Martinez Creek: Perez St to W. Huisache Ave
Solicitation Number: CO-00200
Job No.: 15-4802

ADDENDUM 2
September 27, 2018

Sheet P-33

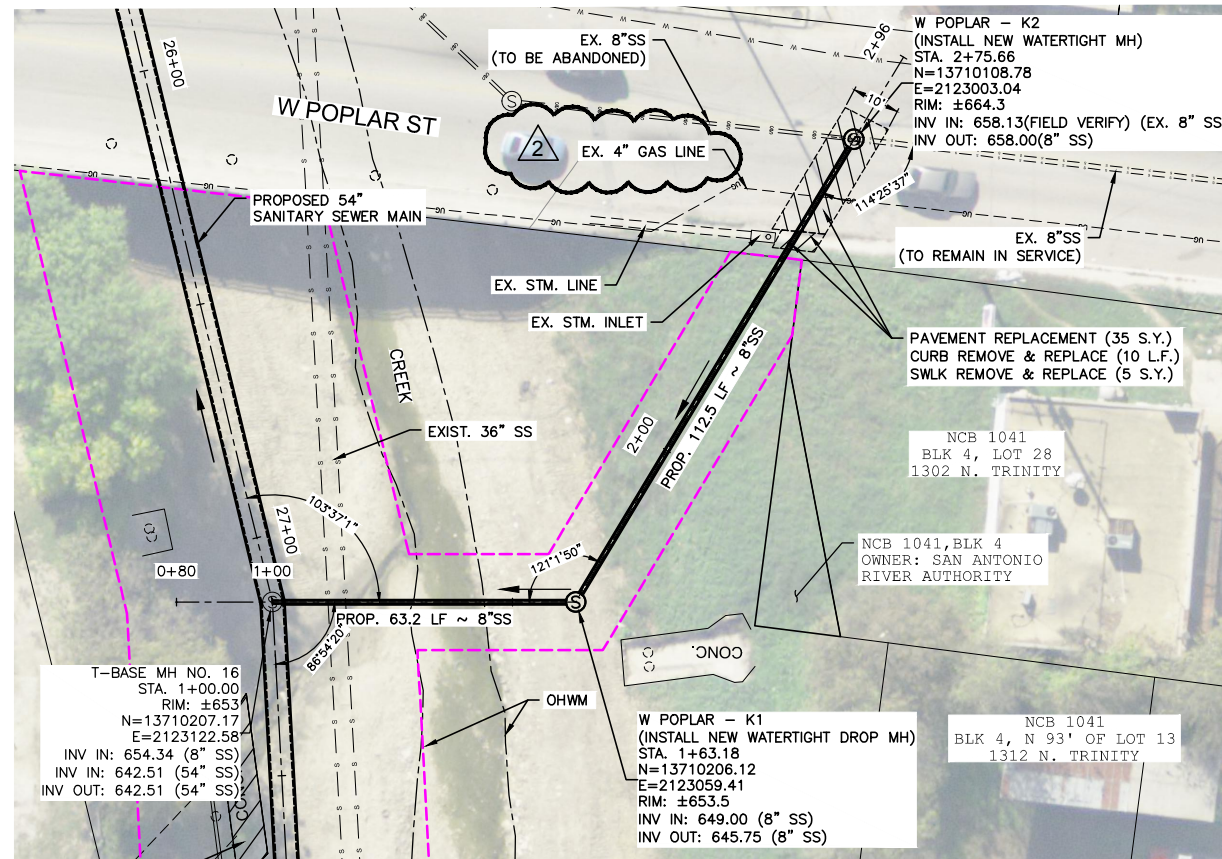
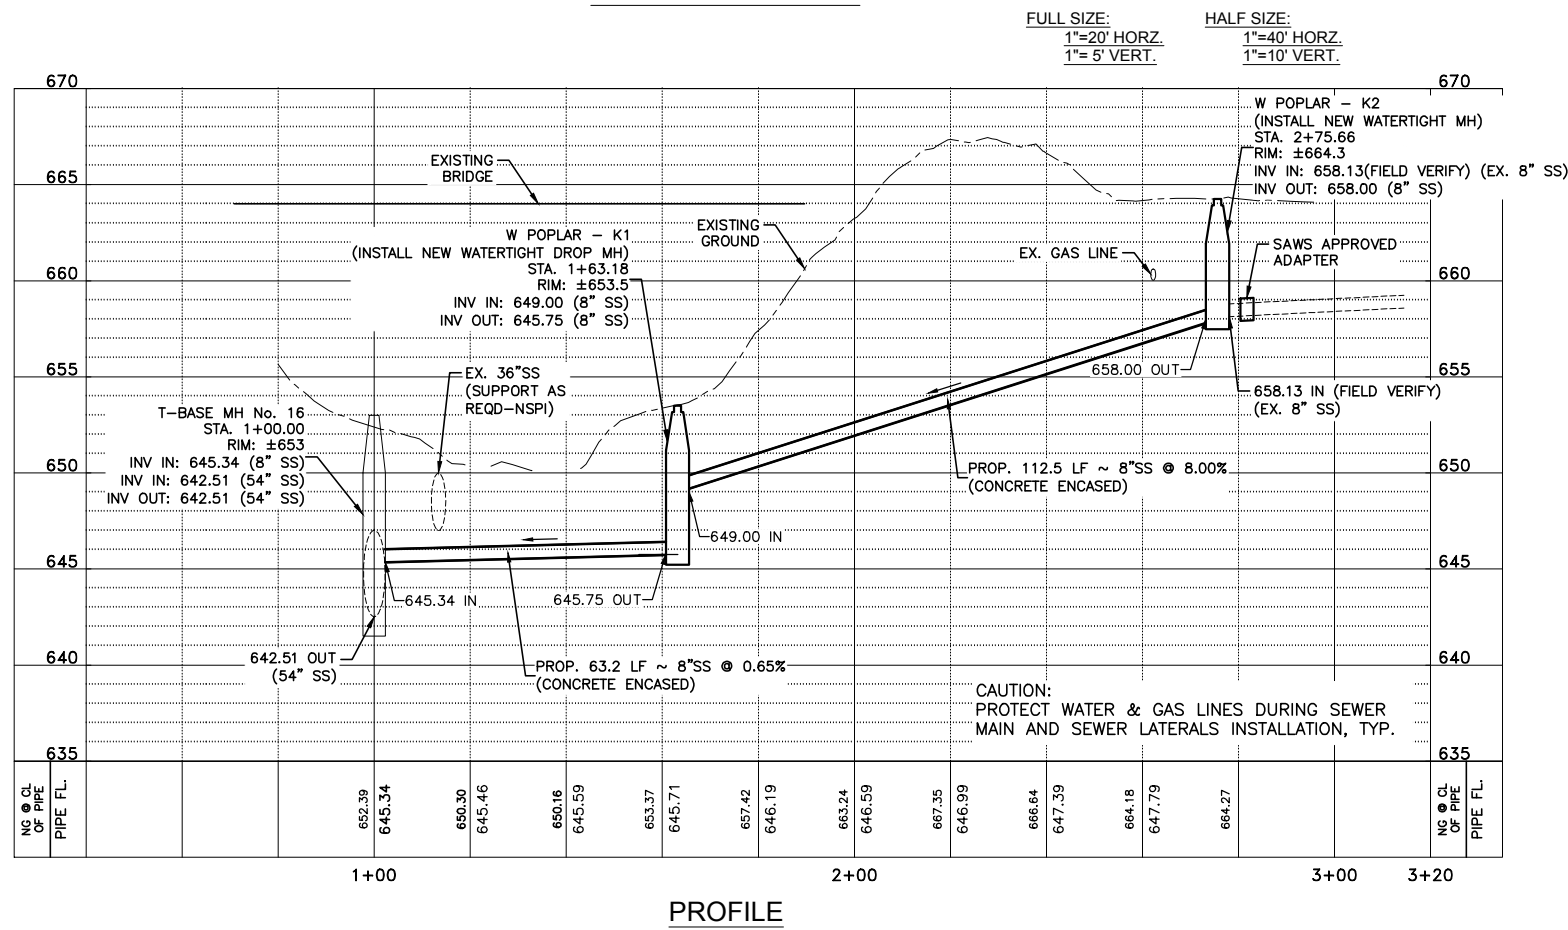
- Sheet P-33: Remove and replace Plan Sheet P-33 with the revised Plan Sheet P-33 attached to this Addendum. Sheet P-33 was revised to add the existing 4-inch gas line.

DATE: 9/26/2018
Sheet P-38
69 of 115

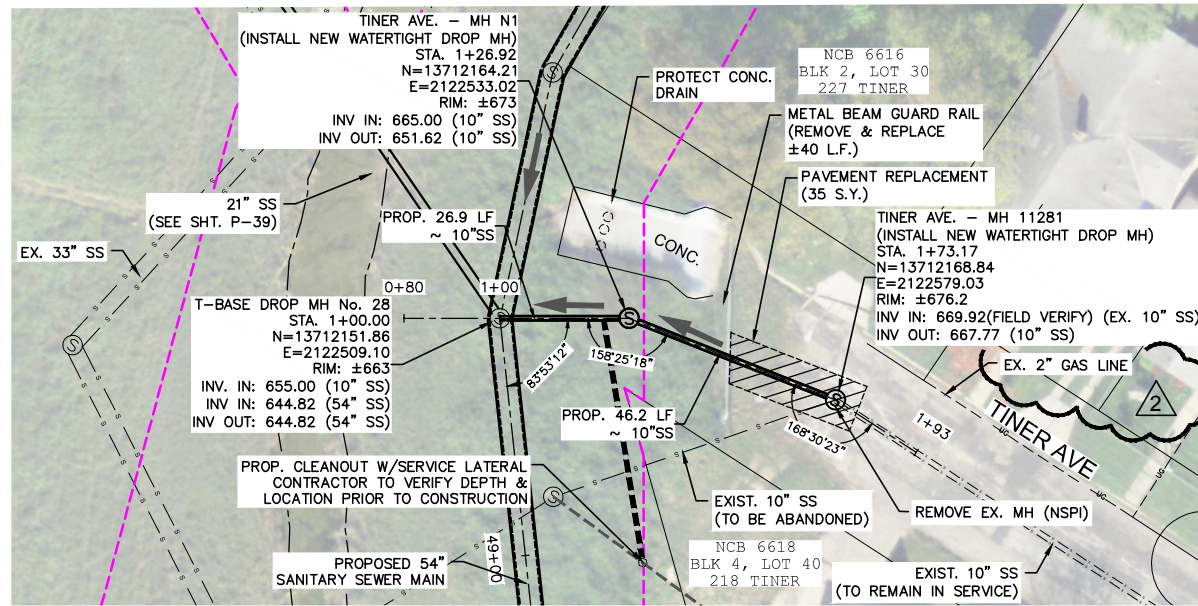
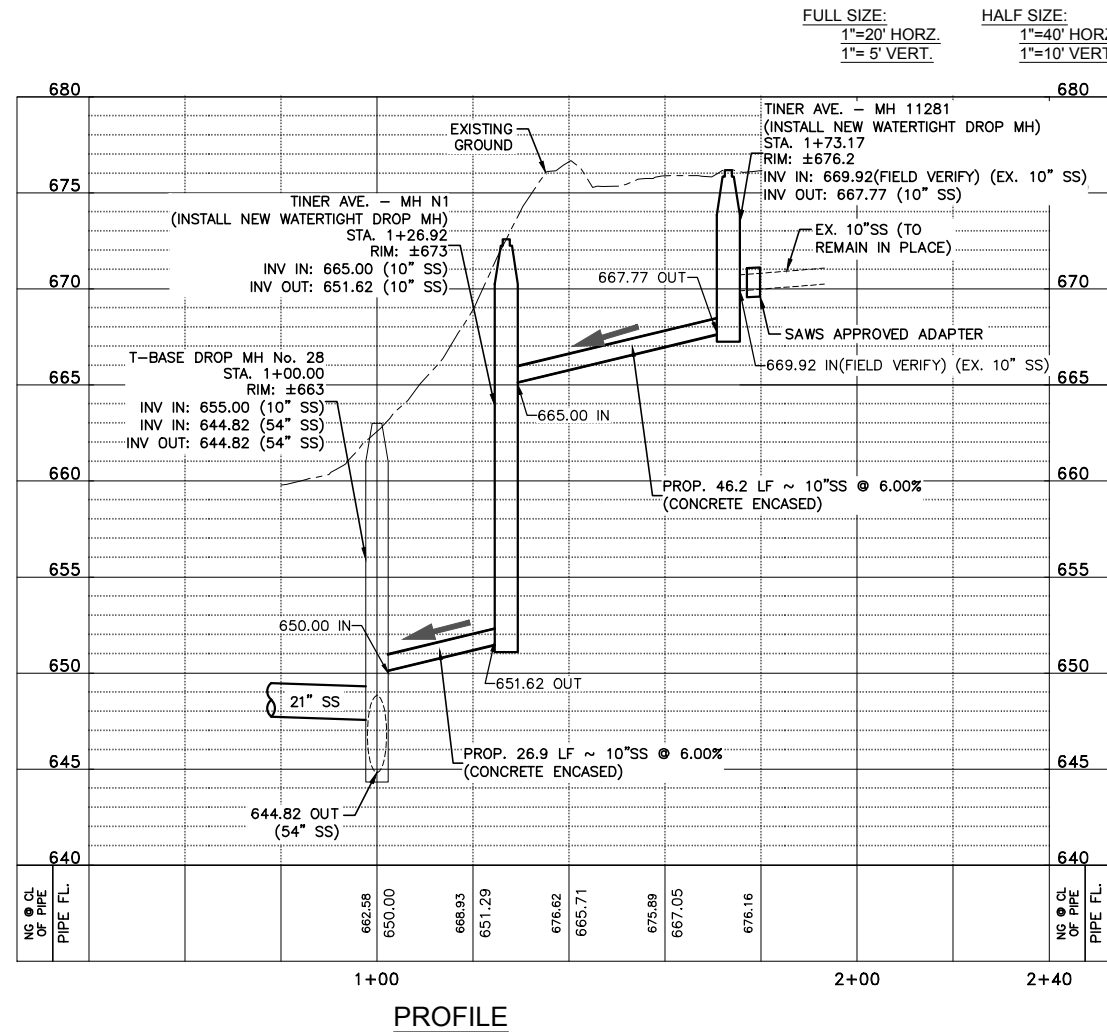
- Sheet P-38: Remove and replace Plan Sheet P-38 with the revised Plan Sheet P-38 attached to this Addendum. Sheet P-38 was revised to add the existing 2-inch gas line.

Sheet P-42

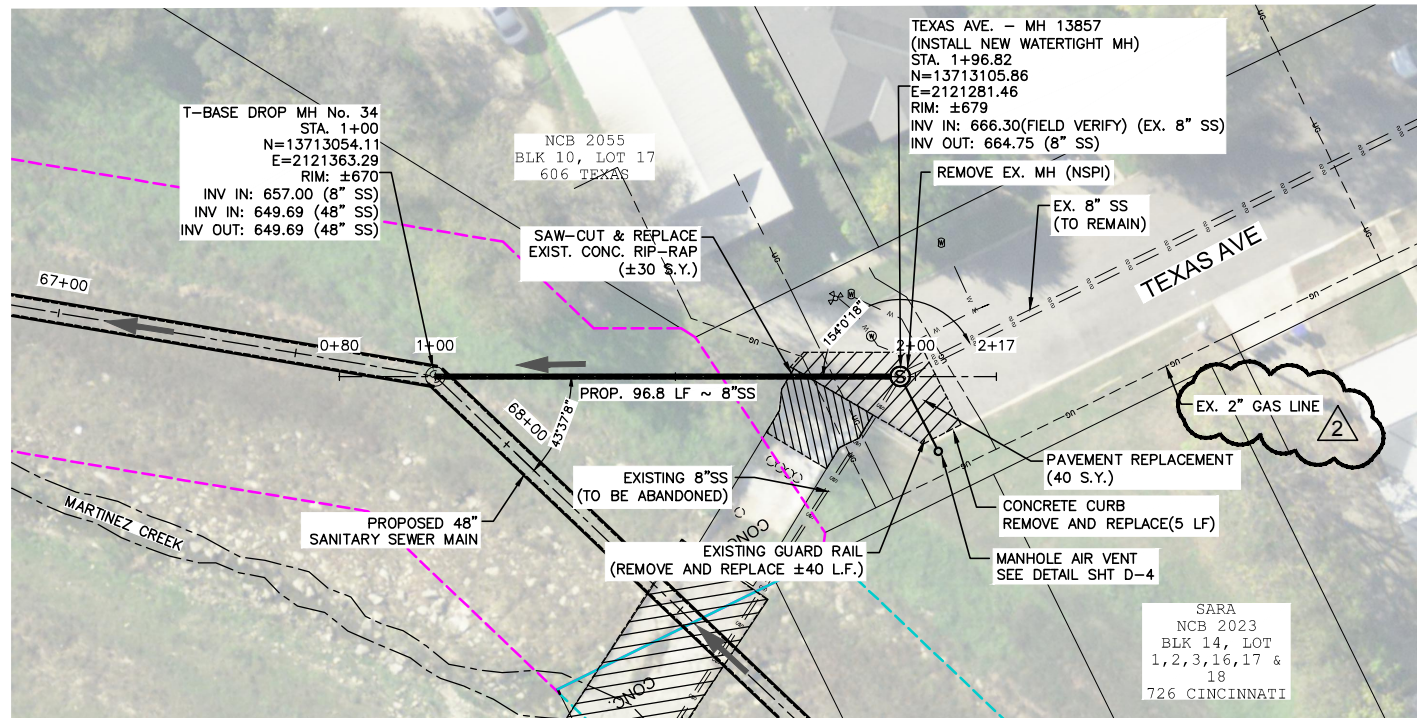
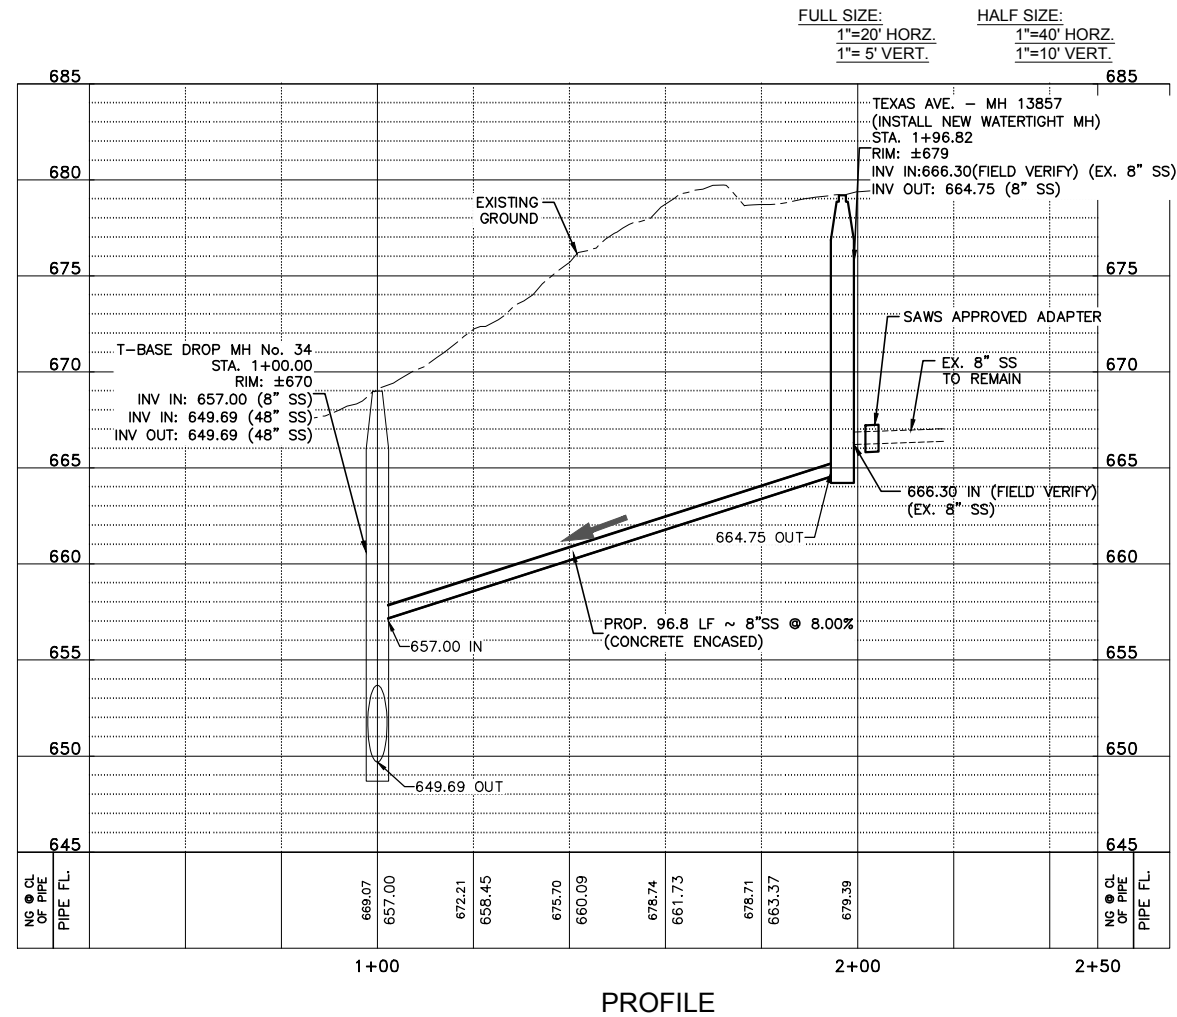
- Sheet P-42: Remove and replace Plan Sheet P-42 with the revised Plan Sheet P-42 attached to this Addendum. Sheet P-42 was revised to add the existing 2-inch gas line.

Sheet P-44A

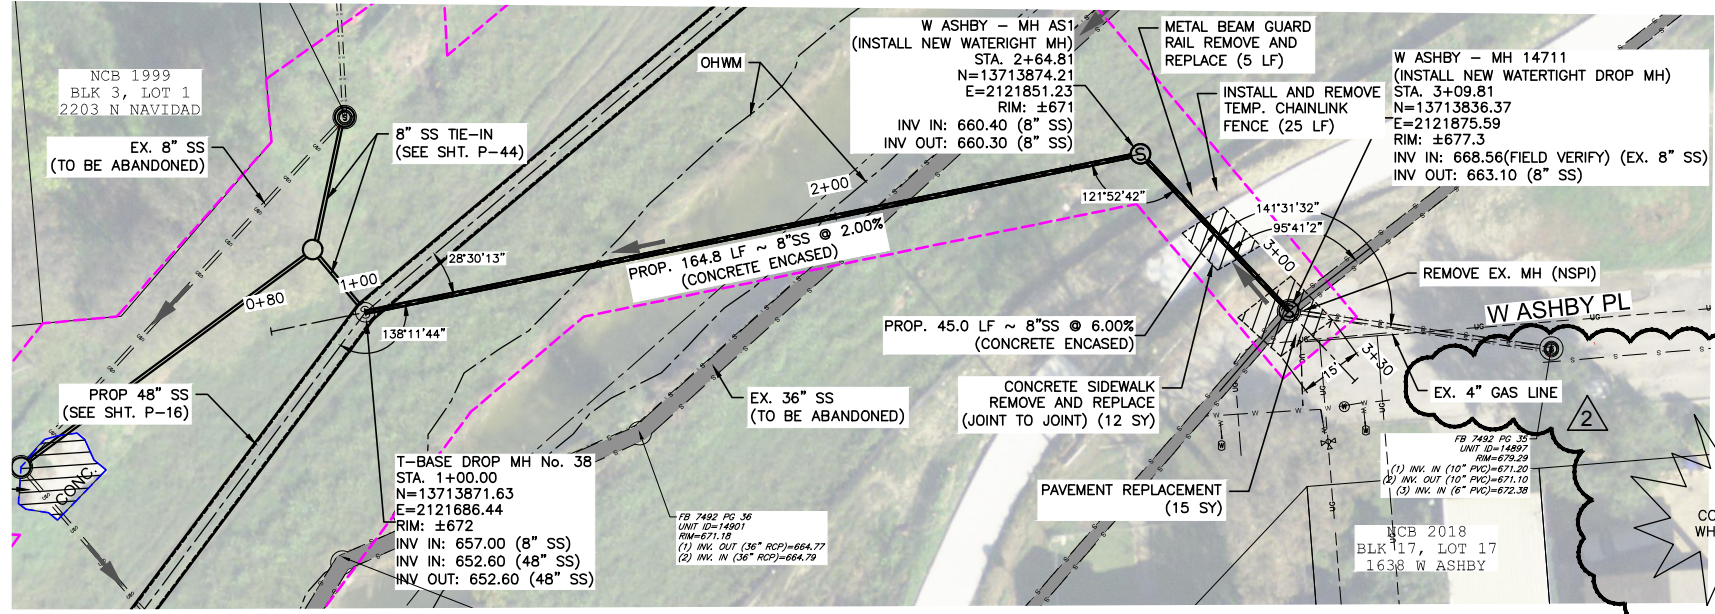
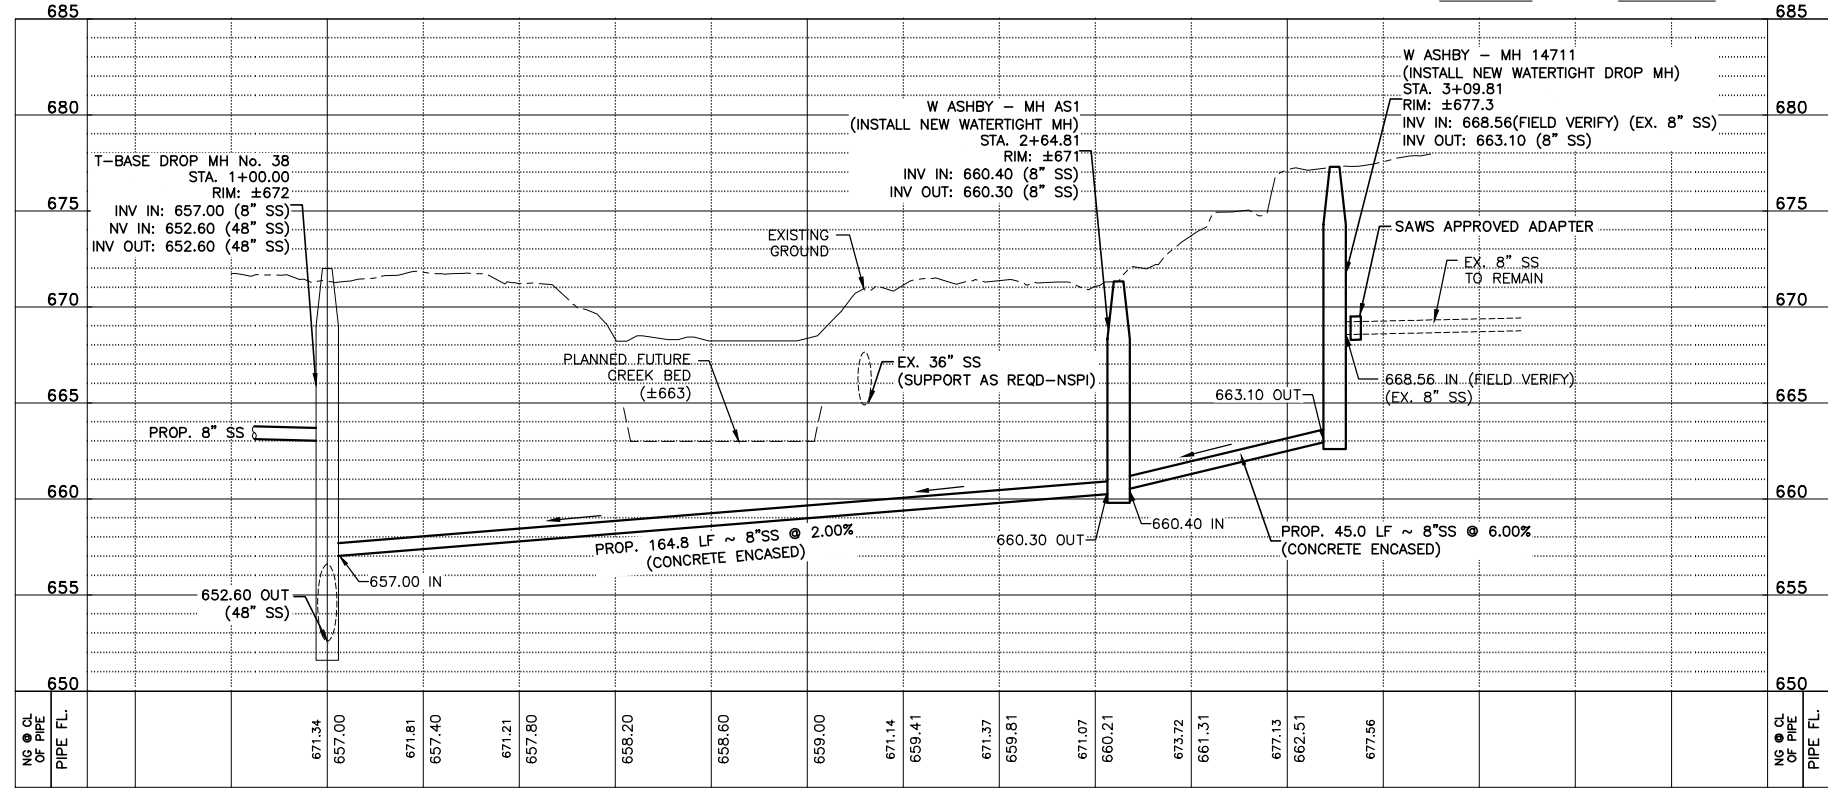
- Sheet P-44A: Remove and replace Plan Sheet P-44A with the revised Plan Sheet P-44A attached to this Addendum. Sheet P-44A was revised to add the existing 4-inch gas line.
